## New “NEXGEN” Seat Securement SERVICE NOTICE #17-0831

### **2” Seat Washers NOT Required**

FIGURE #1

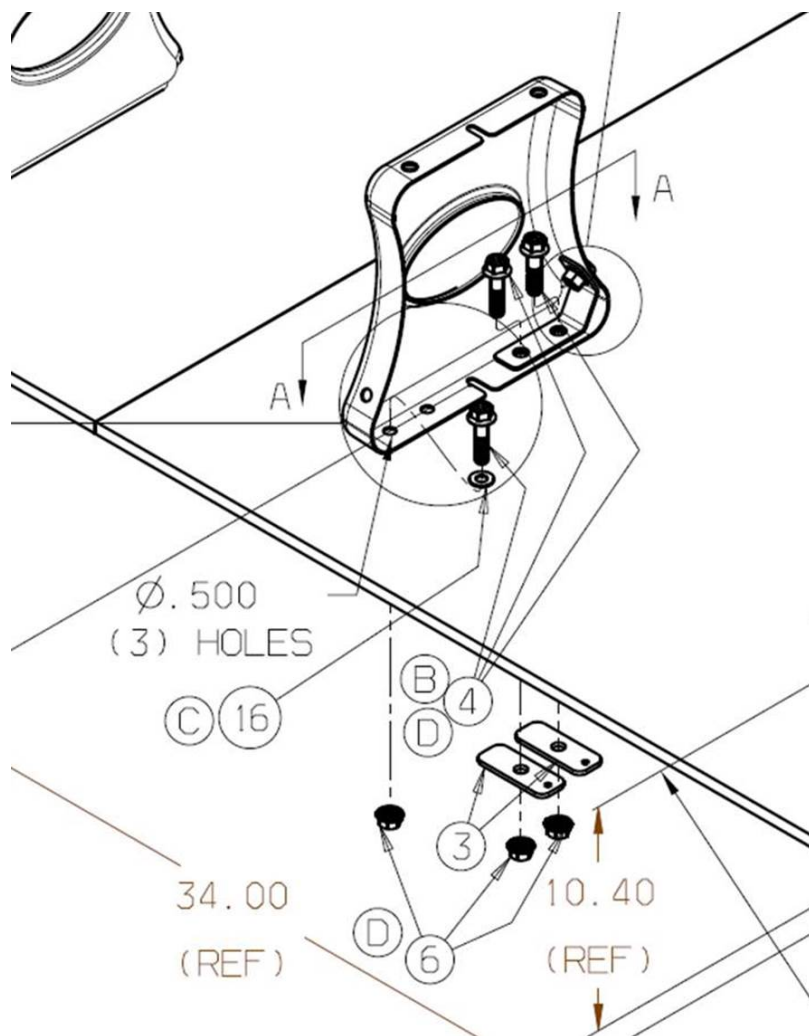
Previous seats on the Type C & D Blue Birds, the bolts used were 5/16” and required a 14 gauge X 2” washer on ALL the bolts. The new seats have a single stamped leg with 3 flange bolts that are 1/2”. The nuts are flanged as well and have a 7/8” flange. The front bolts no longer require washers (FIGURE#1). The 2 rear bolts, which are positioned in the reinforced portion of the seat leg, require a .180 plate (FIGURE #2).
